COUNCIL PANEL ASSESSMENT REPORT

Panel Reference	2017SNH066
DA Number	DA 0307/17
LGA	Ku-ring-gai
Proposed Development	Demolition of a heritage item, tree removal, earthworks, construction and use of hardware building supplies development (Bunnings Warehouse), signage, landscaping, consolidation of titles. Threatened Species Development under the Species Conservation Act 1995 (NSW).
Street Address	950-950A Pacific Highway and 2 Bridge Street, Pymble
Applicant/Owner	Bunnings Properties Pty Ltd
Date of DA Lodgement	1 August 2017
Number of Submissions	2 submissions in response to 1 st notification.
Recommendation	Refusal
Regional Development Criteria (Schedule 7 of the SEPP (State and Regional Development) 2011)	CIV in excess of \$30 million
List of all relevant s4.15(1)(a) matters	<ul style="list-style-type: none"> • SEPP 55 – Remediation of Land • (Draft) Remediation of Land SEPP • State Environmental Planning Policy No. 64 • SEPP (Infrastructure) 2007 • SEPP (Vegetation in Non-Rural Areas) 2017 • Sydney Regional Environmental Plan (Sydney Harbour Catchment) • Ku-ring-gai Local Environmental Plan 2015 (LEP): <i>The former 3M Building at 950 Pacific Highway, Pymble is listed as a loca

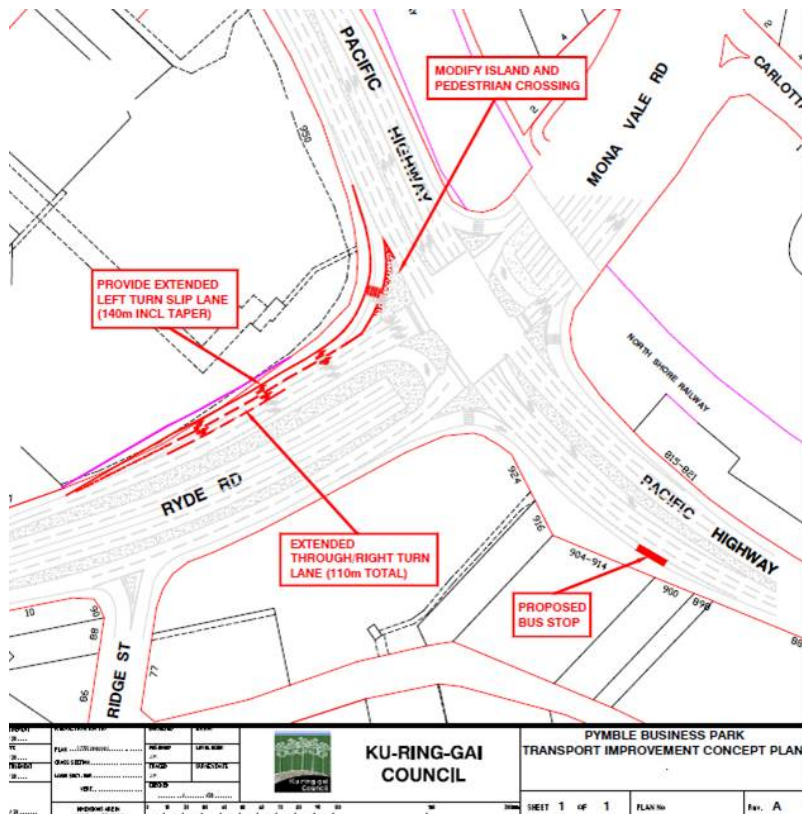
"The intention of the road widening on the Ryde Road off-ramp was that it was to be confined to the Bunnings frontage only and not extend further south-west towards West Street. Below is an extract of the plan of transport improvements for Pymble Business Park (which supports the works schedule in the Ku-ring-gai Development Contributions Plan) which helps to clarify the extent of road widening on the Ryde Road off-ramp and the extent of potential property affectation (purple line on Bunnings frontage).

In relation to the traffic signals at West Street and Ryde Road, Traffic Engineer's comment that "the statement on Page 8 of the TTPA report (re the effect on the interchange) makes it somewhat difficult to argue that the development will have no detrimental impact on traffic if the traffic signal are not provided is concurred with (i.e. send all traffic through the Pacific Highway intersection)"
